**OLD PALM CITY NAC****AUGUST 19, 2018**

I. TITLE: Request for alternative compliance for Palm City Storage (P122-007).

Figure 2. Site Plan

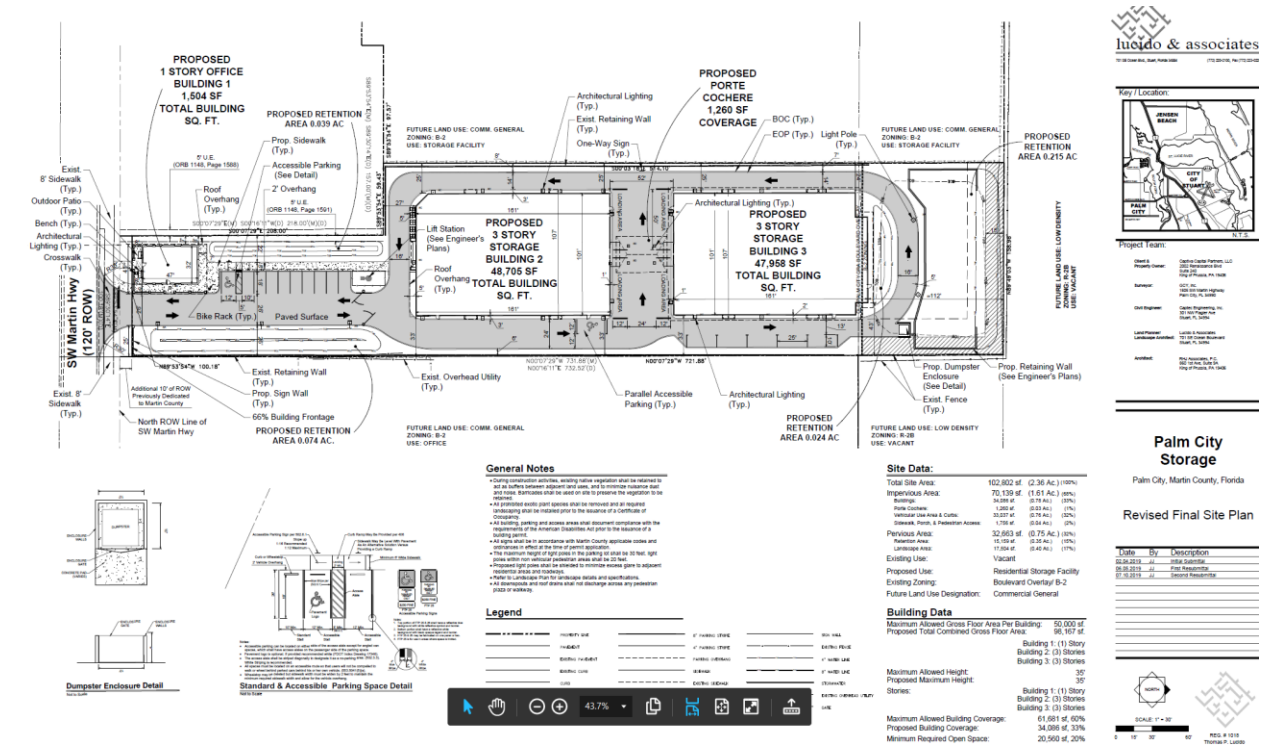
Table 3.265.2. requires minimum building frontage of 50%. Building frontage means the width of the building that abuts the maximum front setback line, as a percentage of lot width.

Analysis: The subject parcel for the storage facility project is narrow where it abuts SW Martin Highway. To accommodate the facility, it was determined that the large storage buildings should be located towards the rear of the site. This will allow vehicle traffic to negotiate the site, provide for the construction of more efficient building space and allow for the security of the site which is imperative of all residential storage facilities.

Access to the site requires a minimum of 26' width at the entrance. This along with the required drive apron adjacent to the road pushed the entrance to 25' from the east property line to accommodate the driveway. The required 6 foot sidewalk around the office building also contributes to the lack of required building frontage.

Overall the narrow lot and required access criteria are not conducive to meeting the 50% required building frontage. The office building was designed to meet CRA design standards and the positioning of the 3 story storage buildings back from the road frontage will create a better public realm.
